TECHNICAL SERVICE BULLETIN

Re: Rear Clutch Spring Seat

MGC Automatic

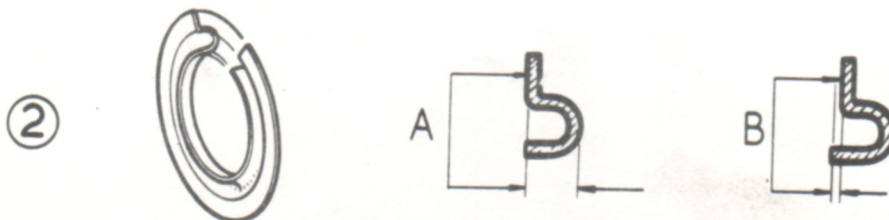
On some MGC Automatic Transmissions it has been found that complaints of

(a) transmission slip on the 2/3 upchange or 3/2 downchange

(b) slip, 'squawk' or judder in reverse

have been due to the rear clutch spring seat 17H 333 (Fig.1) being manufactured incorrectly, thus limiting the rear clutch piston travel and preventing the clutch from fully engaging.

When a transmission is being stripped for the above faults (or for any other reason) this part should be checked. If the two faces are not in line within 0.020", as at 'B' (Fig.2) a new part correct to drawing - see 'A' (Fig.2) - should be fitted. If no replacement is available, the excess material may be removed by grinding.
